**Staff Report for a Single Family Home in the Canemah Historic District  
April 17, 2017**

**FILE NO.:** HR 17-01: Historic Review Board review of construction of a new single family residence in the Canemah National Historic District.

**REQUEST:** Construction of a new single family dwelling in the Canemah Historic District.

**RECOMMENDATION:** Approval with Conditions

SHEET #  
**A2.1**  
ELEVATIONS

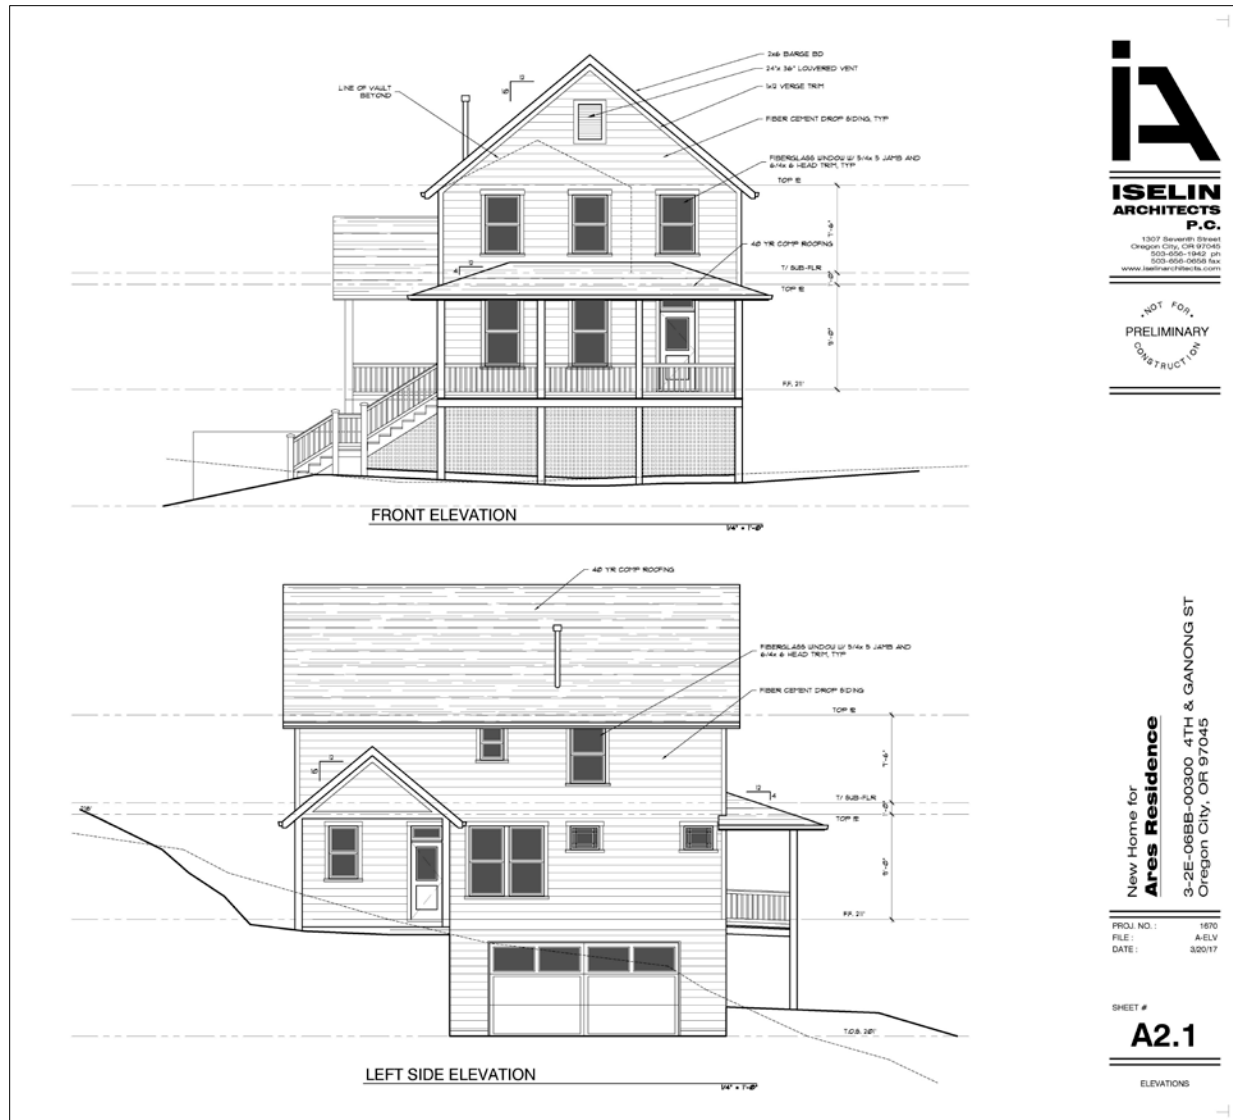
- The garage. The proposal includes an attached garage below the proposed home. The applicant has not provided sufficient evidence as to why the site constraints dictate that the garage must be attached onsite, particularly when the previous design for the home included a detached garage. **Staff has determined that it is possible, likely and reasonable that the applicant can meet this standard through the Conditions of Approval.**

In the elevation drawing provided by the applicant there is significant basement massing on the north and west side of the proposed home.

Staff has identified massing along the north and east side of the proposed home. The home has been set back approximately 20 feet from the adjacent right-of-way to help mitigate for the massing along the right-of-way. The applicant should incorporate landscaping into the design of the home to help reduce the impact of the new home on the surrounding neighborhood. The applicant shall address the massing on the front and east side of the home, incorporating the existing vegetation would help to mitigate for the impacts of the proposed massing on the surrounding neighborhood. To mitigate for the massing in

1. The proposed garage located underneath the home shall be removed. The area shall be regraded to accommodate the proposed single family home.
2. Incised lumber or pressure treated wood shall not be used on any visible surfaces. (P)

the front of the home one tree (at least 10 feet in height when mature) and four shrubs (at least 3 ½ feet in height when mature) shall be install in front of the home.
